ATTACHMENT P9

OLDER USACE CONSULTATION MATERIALS: MCA 02/22/2019 LETTER

Reference: State Pier Infrastructure Improvements, New London, CT

ATTACHMENT N: U.S. ARMY CORPS OF ENGINEERS DEEP PERMIT CONSULTATION FORM

FIGURE 2: PROPOSED IMPROVEMENTS TO THE STATE PIER

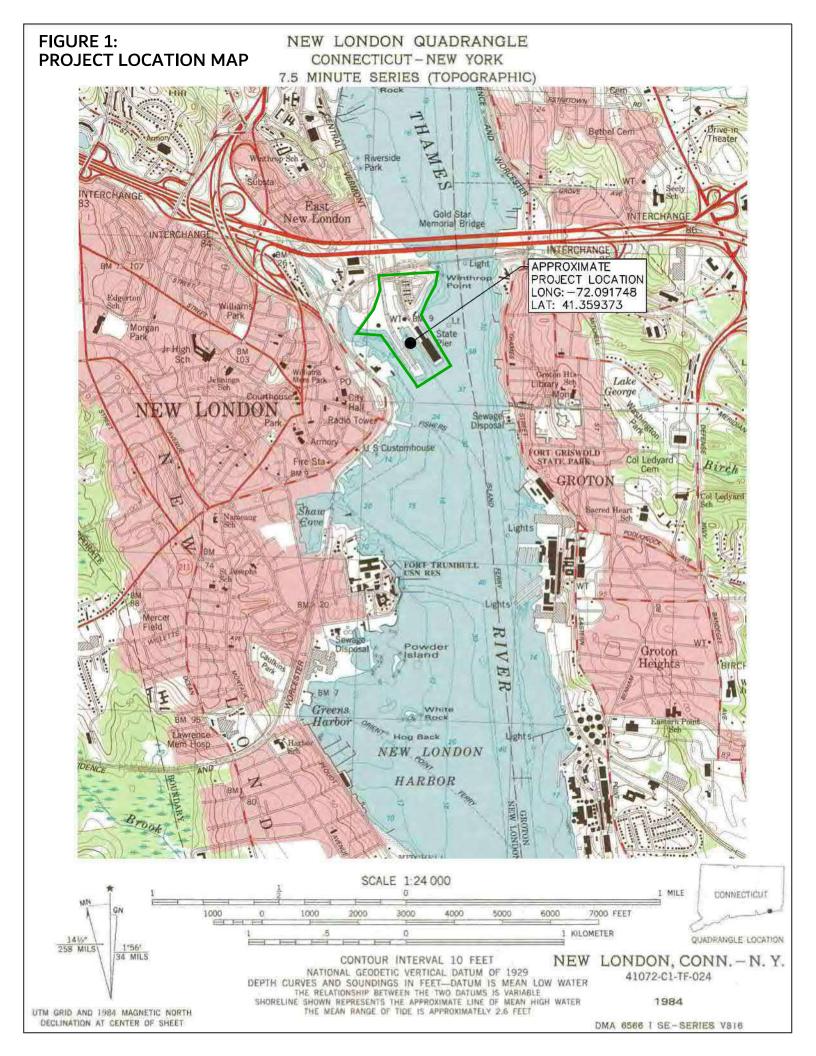
We will be reviewing this as a Standard Permit, requiring a submittal of application form 4345, final plans - showing project limits and Federal navigation channel limits; and an alternatives analysis.
